# Transmittal of Drawings

| **CSI Job #** | **C22312** | **Submittal No:**<br><br>**Revision No:** | C22312 - Submittal-002217 - BC/CS-BOX CULVERT W/CS WW |
| **Project:** | VT/DOT Bridge Replacement - Roadway Improvements TH 3 FAS 0302 in RICHFORD, VT | **Project No /**<br>**Contract No(s):**<br>**Federal Aid No(s):** | BRF030229 / |

D | 26' SPAN X 10' RISE 3-SIDED CULVERT | REV 3
Drawing No. C22312-L01A
Quantity: 1 | Project No: BRF030229 | SHEET 1 OF 2

D — 26' SPAN X 10' RISE 3-SIDED CULVERT — REV 3
Drawing No. C22312-L01B
Quantity: 1 — Project No: BRF030229 — SHEET 2 OF 2

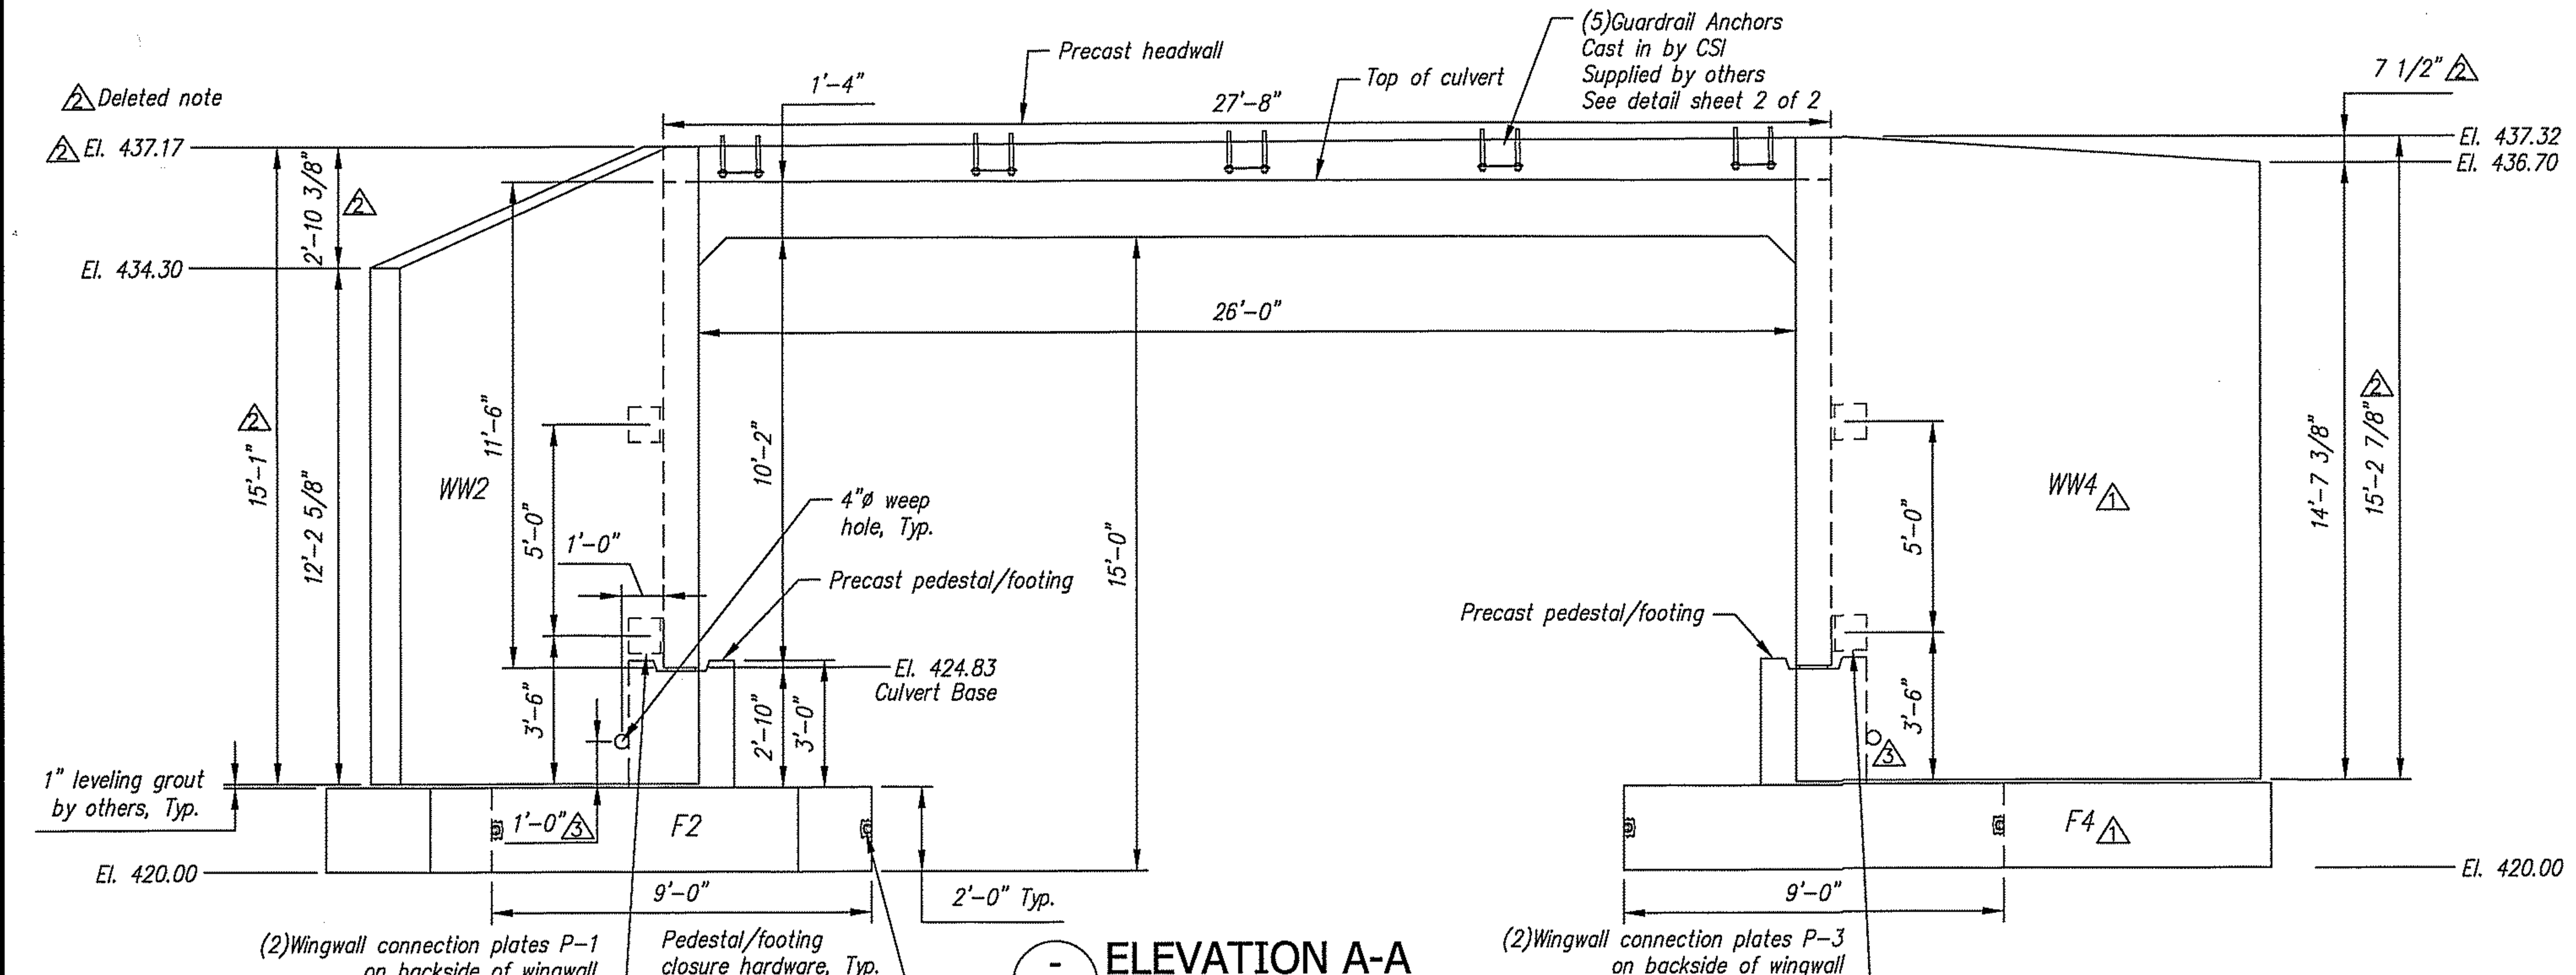
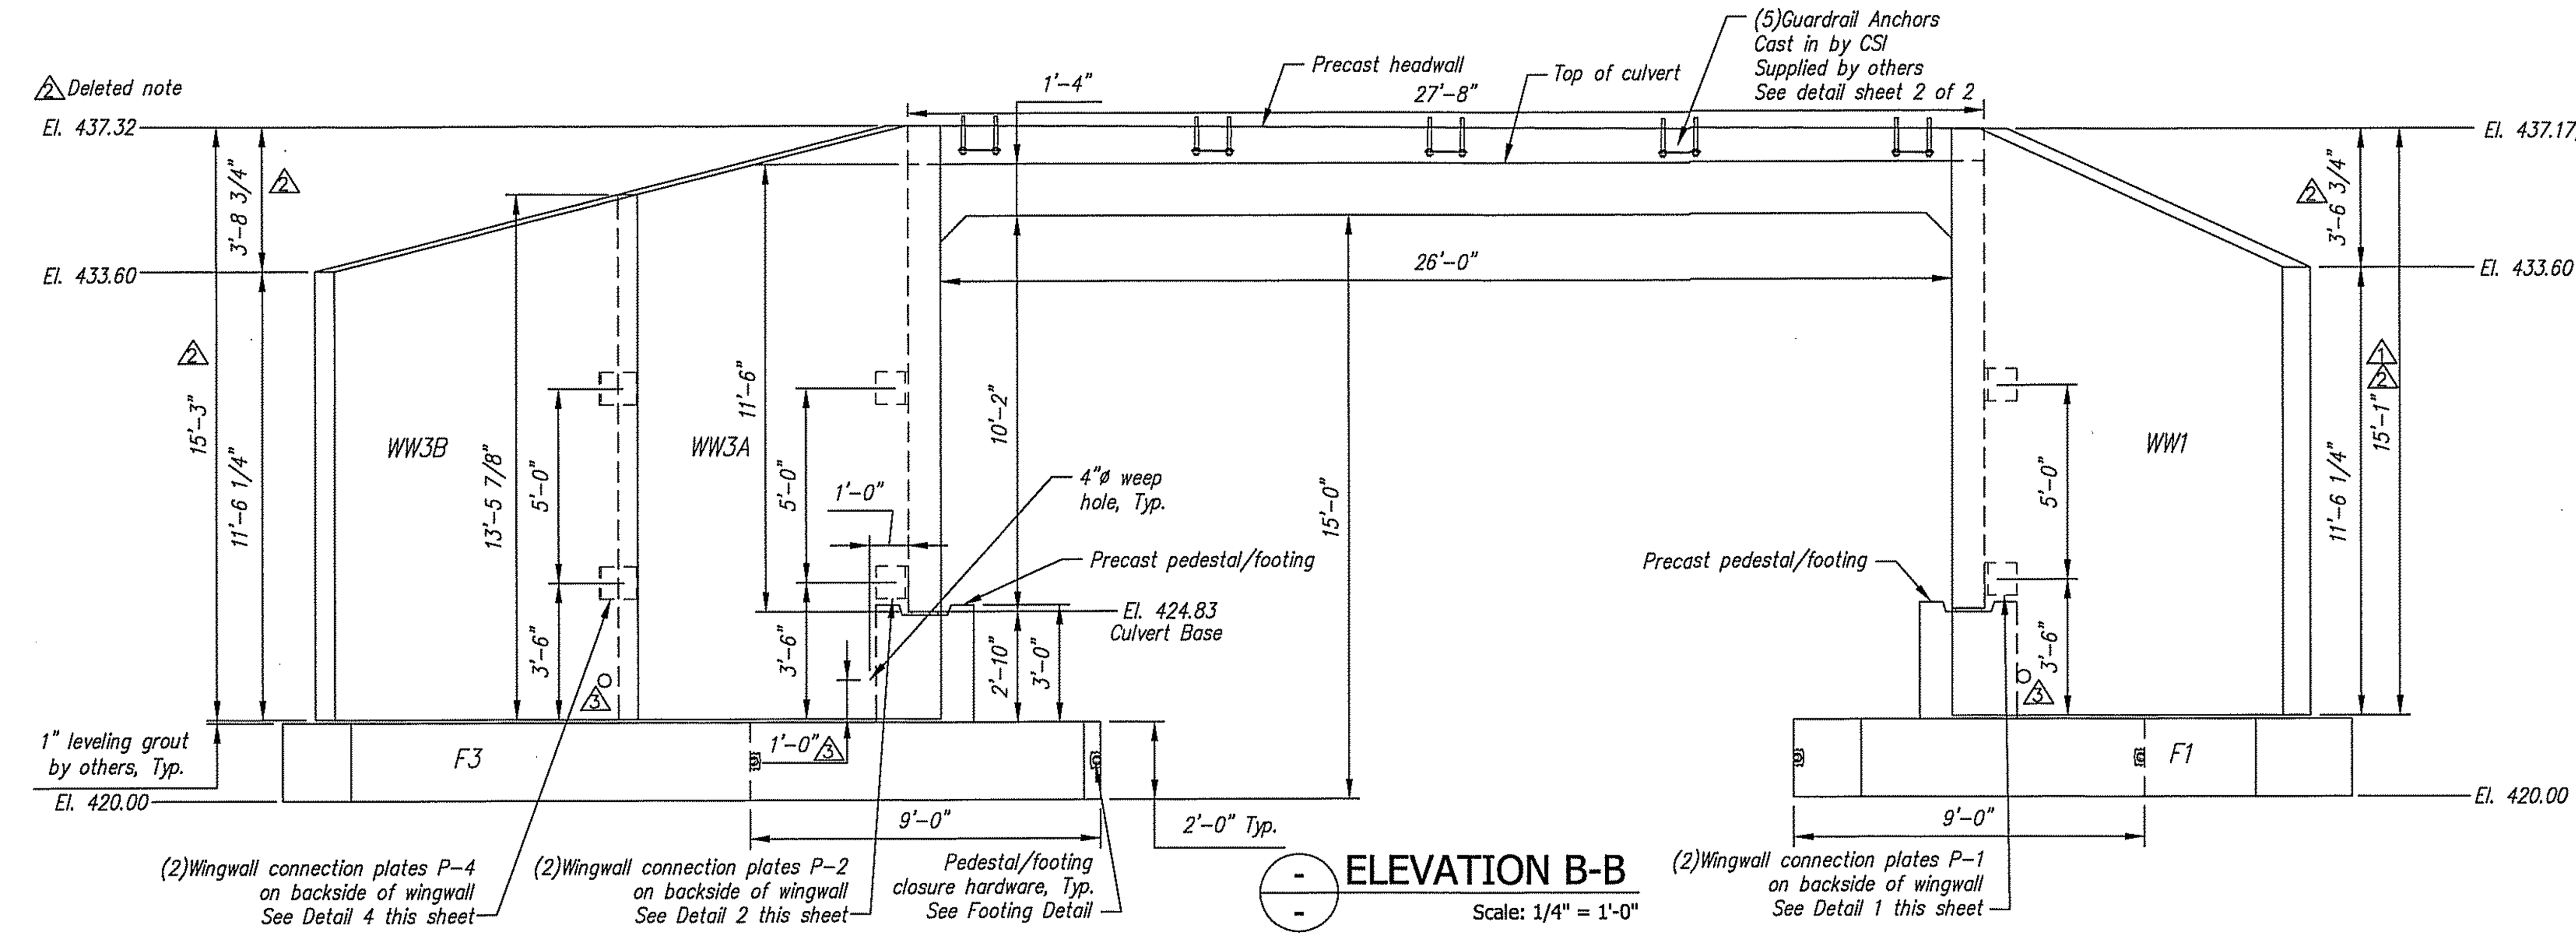
| Rev. | Date | DESCRIPTION | By |
|---|---|---|---|
| 2 | 28MAY2015 | EL A-A & B-B: 437.17 WAS 437.13, EXTENDED WINGWALLS EVEN WITH HEADWALL | RY |

C — SHOP DRAWING C1 — Drawing No. C22312-C1 — REV 3

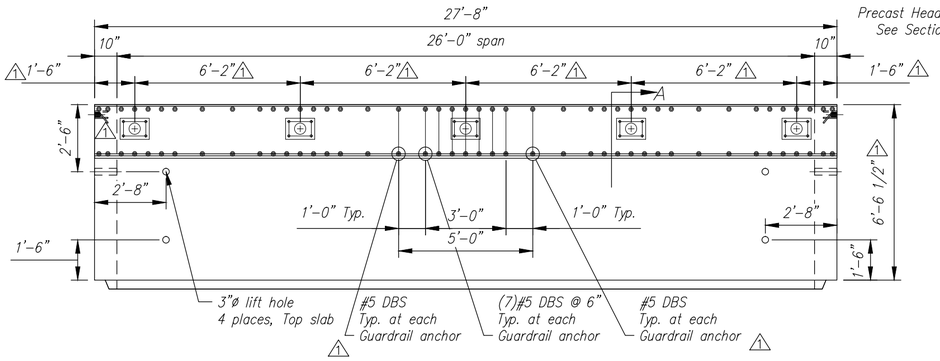
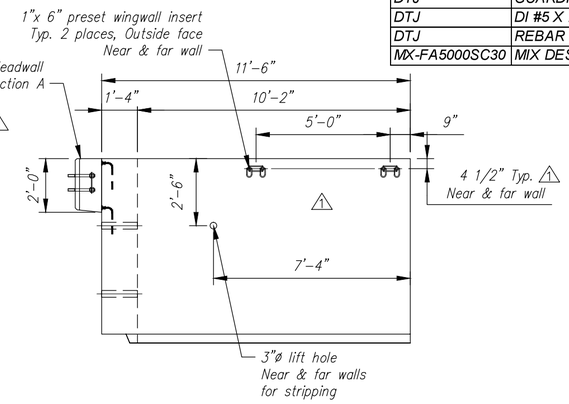
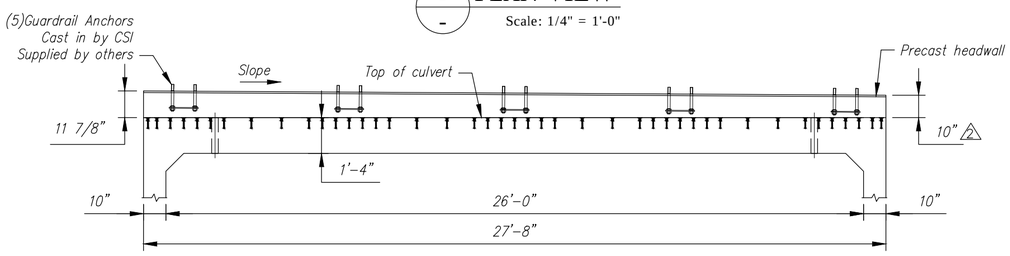
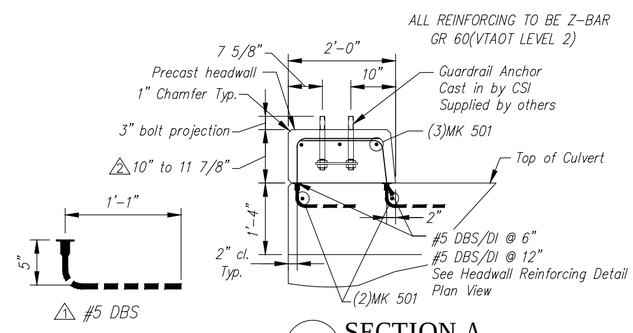
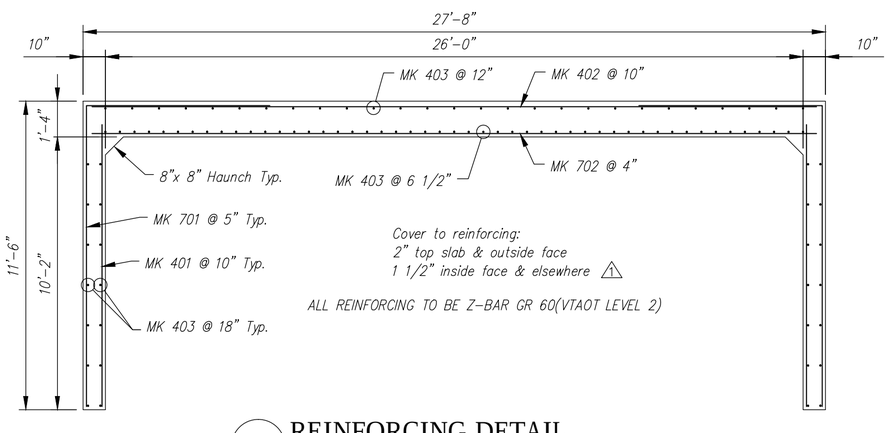
| Rev. | Date | DESCRIPTION | By |
|---|---|---|---|
| 3 | 10JUN2015 | ADJUSTED WATER REPELLENT | RY |
| 2 | 28MAY2015 | 10" WAS 9 1/2", HDWALL BEND SCHED – 8" WAS 7 1/2" | RY |
| 1 | 14MAY2015 | REVISED PER CUSTOMER REVIEW, REVISED GUARDRAIL ANCHOR SPACING, MOVED WINGWALL ANCHOR, ADDED NOTE | RY |

C | Drawing No. SHOP DRAWING WW3B | REV 3
C22312–WW3B

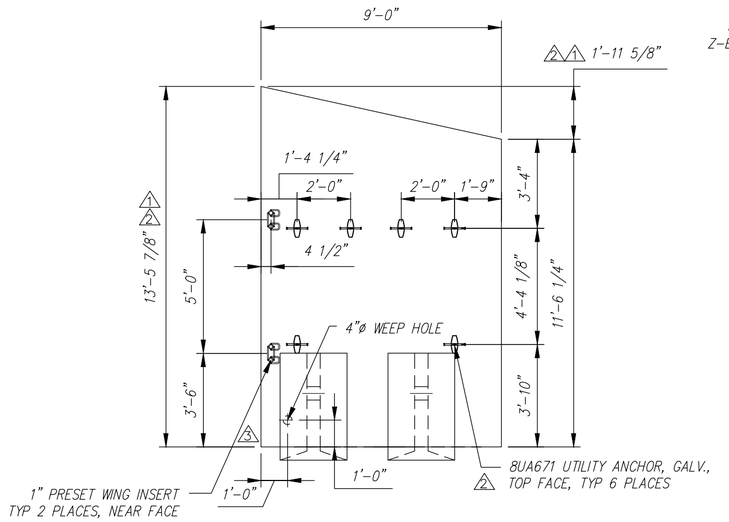
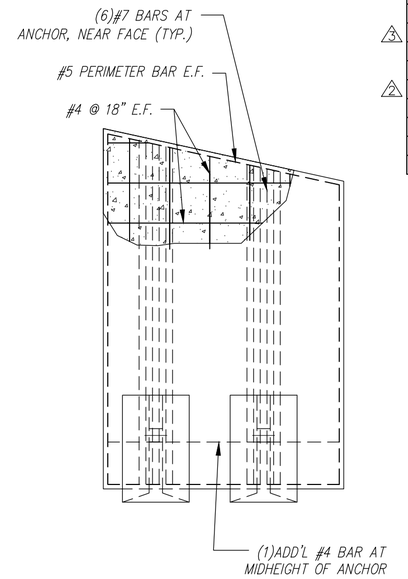
| Rev. | Date | DESCRIPTION | By |
|---|---|---|---|
| 3 | 10JUN2015 | ADDED WEEP HOLE | RY |

C | SHOP DRAWING WW4 | REV 3
Drawing No. C22312–WW4
Quantity: 1 | Project No: BRF030229 | SHEET 8 OF 14

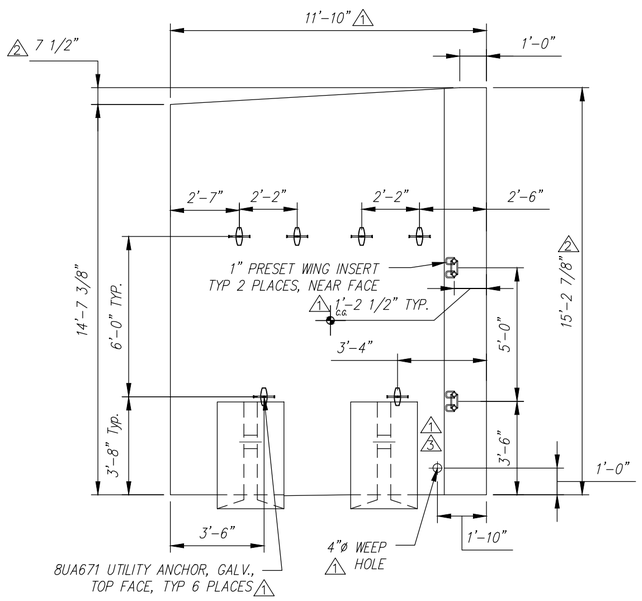
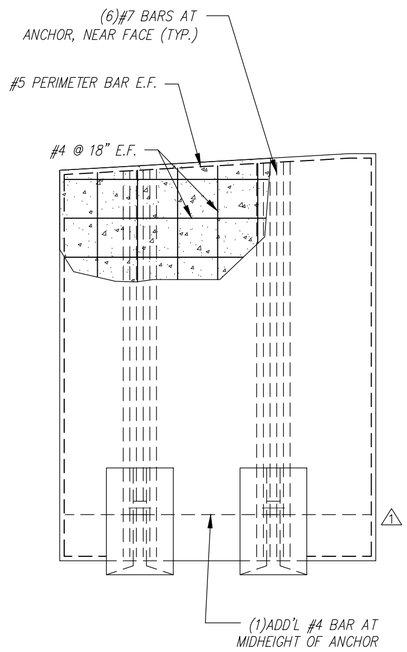
| Rev. | Date | DESCRIPTION | By |
|---|---|---|---|
| 3 | 10JUN2015 | ADDED 6" STANDOFF | RY |

C | Drawing No. SHOP DRAWING F3A / C22312–F3A | REV 1

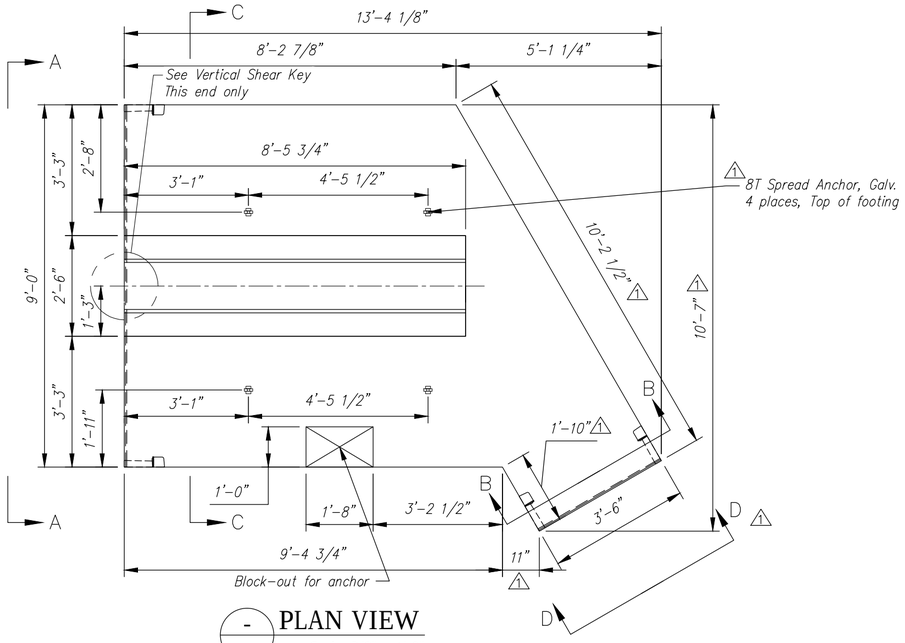
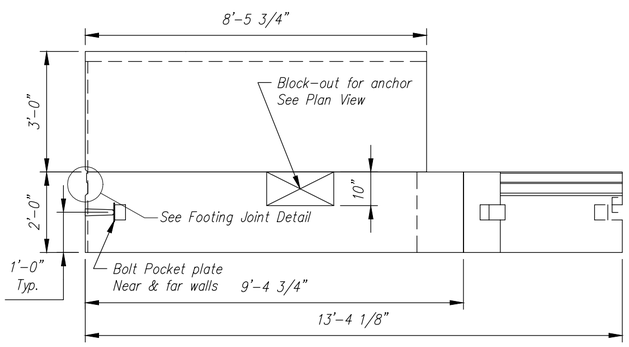
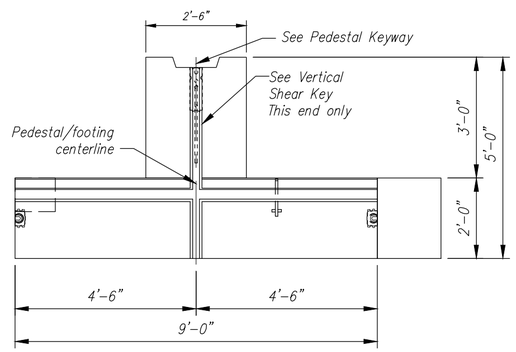
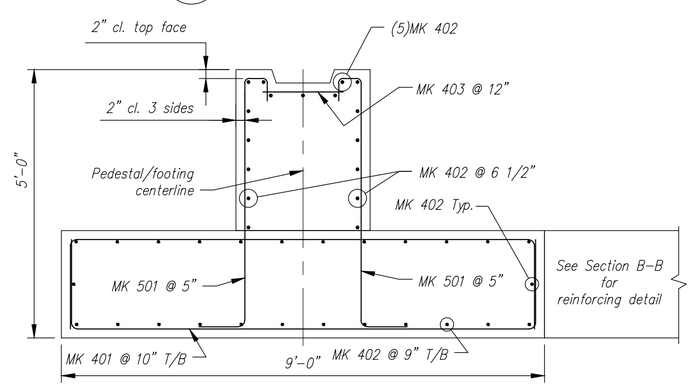
| Rev. | Date | By | DESCRIPTION |
|---|---|---|---|
| 1 | 14MAY2015 | RY | REVISED PER CUSTOMER REVIEW, REVISED FOOTING, ADDED BOLT POCKETS,REVISED ANCHOR LOCATIONS |

C | SHOP DRAWING F4 | REV 2
Drawing No. C22312–F4
Quantity: 1 | Project No: BRF030229 | SHEET 12 OF 14

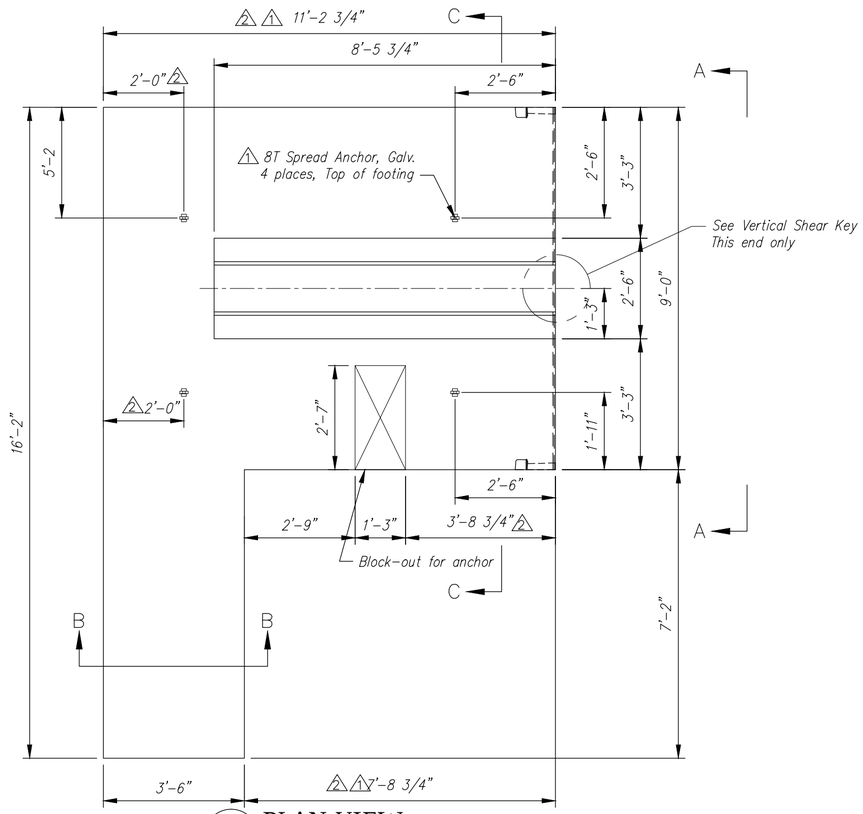
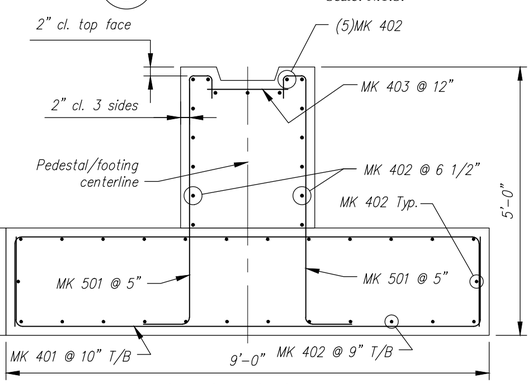
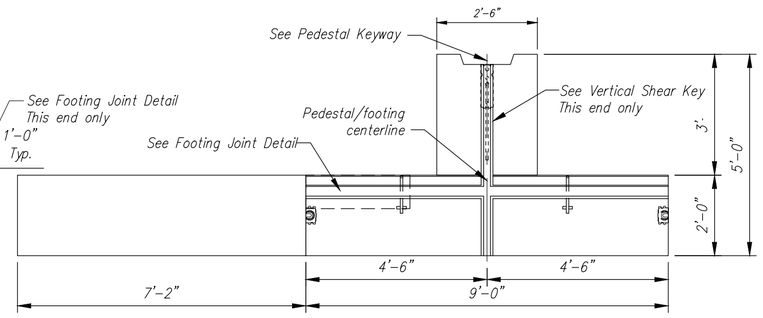
| Rev. | Date | DESCRIPTION | By |
|---|---|---|---|
| 3 | 10JUN2015 | ADDED 6" TO WIDTH, 11'-2.75 DIM WAS 10'-8.75 | RY |
| 2 | 14MAY2015 | REVISED PER CUSTOMER REVIEW, REVISED FOOTING DUE TO WINGWALL RELOCATION | RY |
